# Service bulletin

C. 242  
EXP. 10

MUD PENETRATION - CONVERTER HOUSING

Wolseley  
24/80  
Automatic

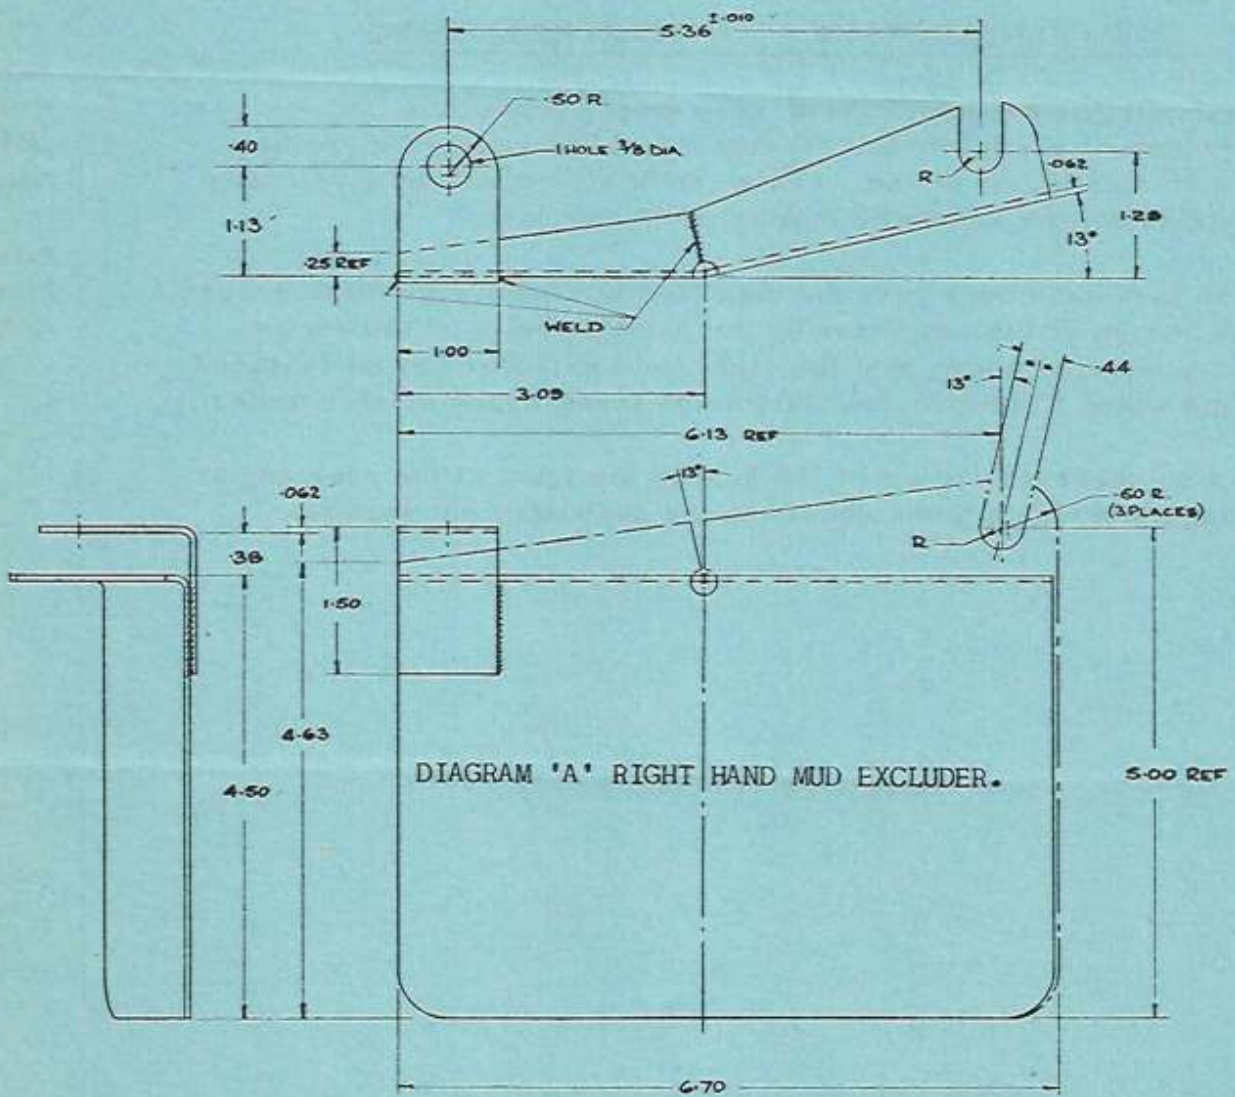
Fit the mud excluders over the right and left hand wire mesh screen at the bottom of the converter by the existing bolts on the engine rear back plate, noting that the right hand excluder has an extended bracket which fits under the bottom set screw of the starter motor.
